RE: Review and Comments of the Facility Closure Plan for Hanson Aggregates Radium Facility, 3000 Busch Road, Pleasanton California

The Livermore-Pleasanton Fire Department has reviewed the Facility Closure Plan prepared by LFR Inc. for the above mentioned facility. The Closure Plan and supporting documentation address Areas of Concern Numbers 1 through 3. Thank you for submitting this hazardous materials closure plan, our comments and required amendments to the plan follow.

Notification Plot

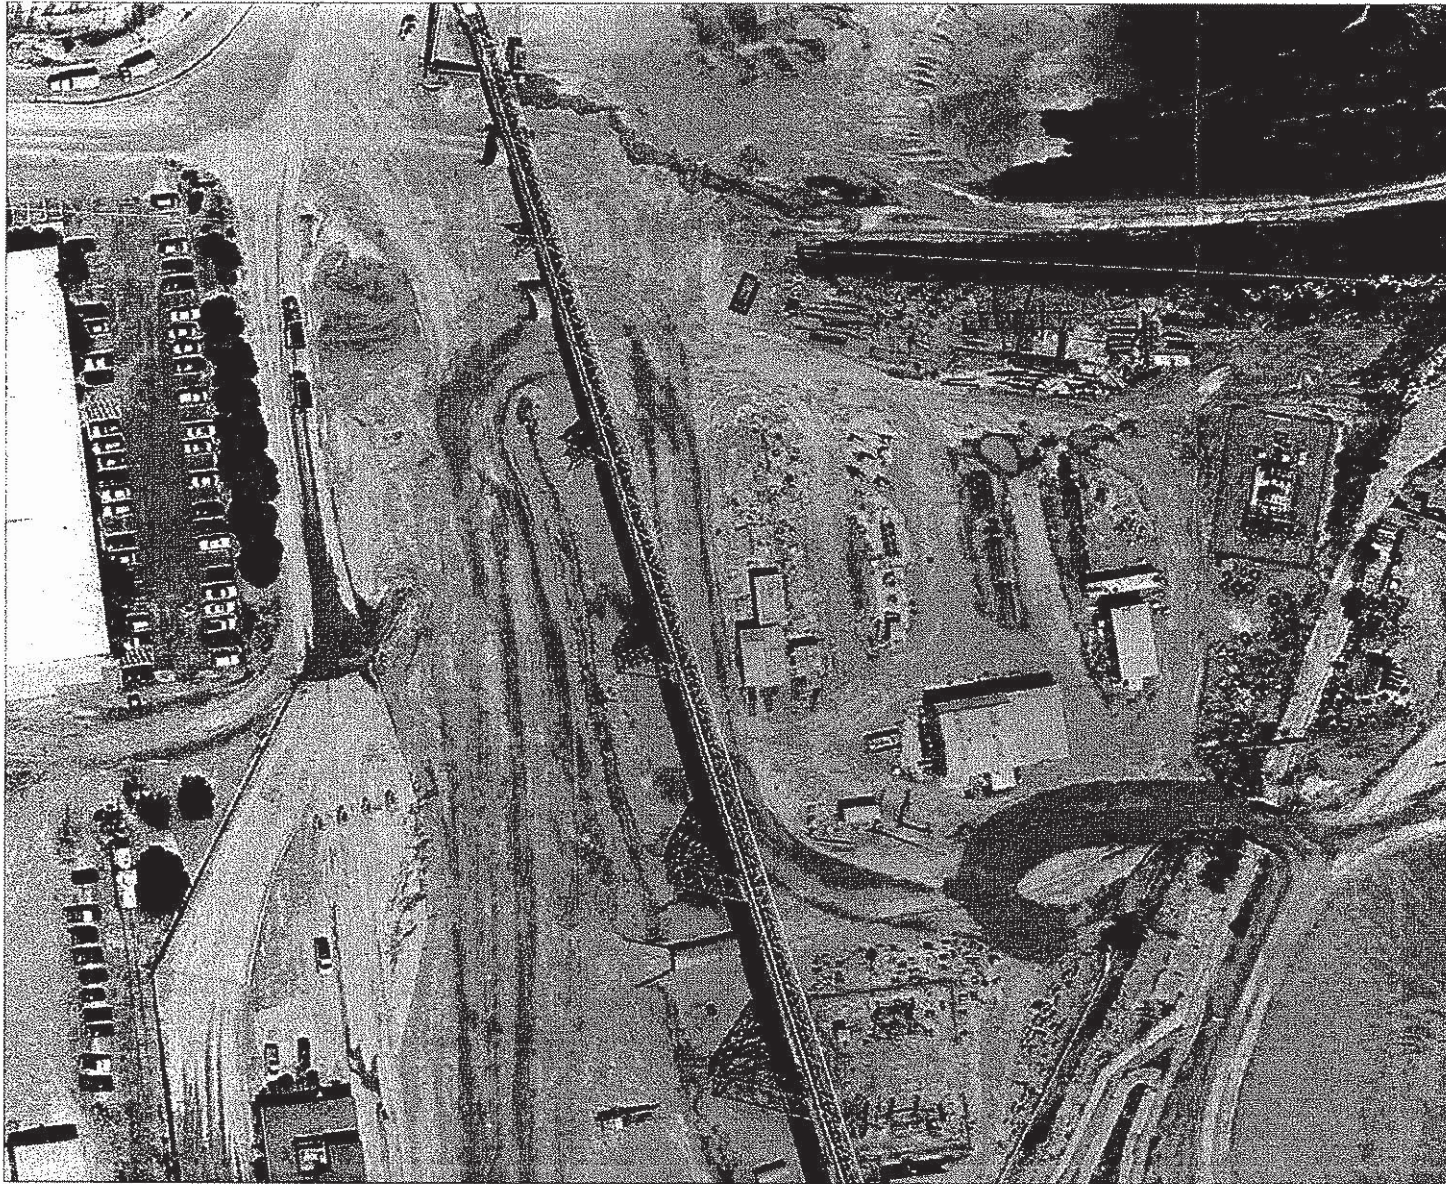
6. To-date, very little hazardous materials storage and use information has been provided for the area east of AOC 3. This area contained main electrical switching and transformer equipment, part of the overhead conveyer system, and various buildings and structures (see attached aerial photograph). During our inspection of September 16, 2004, this was one of the areas visited by Larry Appleton and myself. Many of the structures were in the process of being torn down, and the area was being graded with heavy equipment. One of my concerns (among others) was the large electrical transformer units containing regulated levels of PCB's. Please see the attached copy of the inspection report and the concerns raised. These need to be addressed.

Provide additional information for this area including building locations, uses, hazardous materials storage and use (including quantities), and closure activities conducted to-date. In addition, provide sampling results (soil, material, waste, etc.) and disposal documentation.
 7. In the final Closure report, provide disposal documentation for all hazardous materials and wastes handled during this facility closure. Please ensure the document copies can be read, and the signed TSDF copies of the manifests are included.
